#### **New Albany Planning Commission Agenda**

#### ZC-11-2023 Rezoning

#### FPL-12-2023 Final Plat Modification

#### FDP-50-2023 Final Development Plan

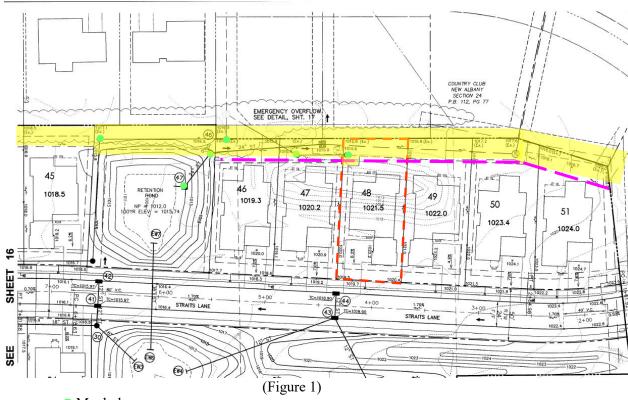
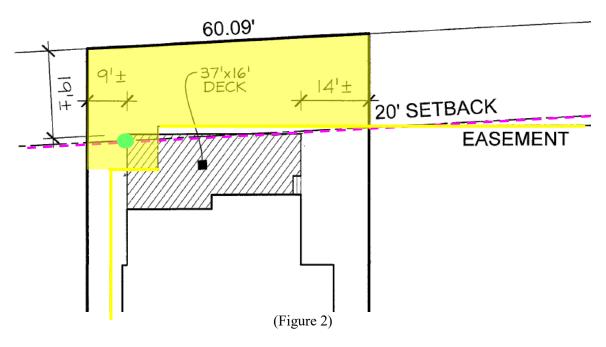
- 3. This drainage easement serves multiple properties and connects to the stormwater basin to the south of the property. This infrastructure serves homes in the immediate area and seven homes south of the property as well. According to the engineering plans, this easement contains a buried stormwater sewer pipe to allow water into a stormwater basin "B" and from Straits Farm and the Fenway subdivision (As Seen in Figure 1).

- 4. The drainage easement contains a manhole and stormwater pipe. This manhole structure is used to access and maintain the stormwater sewer system beneath the ground (as seen in Figure 2).

5. This variance appears to be substantial due to the location of the deck in an area where city infrastructure is constructed. There are public utilities consisting of a manhole and underground storm piping within the drainage easement located in the rear of the property. This underground stormwater pipe distributes water to the neighboring

1. The homeowner enters into a hold harmless agreement (or similar legal mechanism to be determined by the city engineer and/or attorney) specifying that the property owner, and not the city, is responsible for any damages to the deck in the event that a public or private utility provider needs to access the easement area prior to the issuance of a building permit and any impacts to neighboring surface drainage must is the responsibility of the homeowner to address.
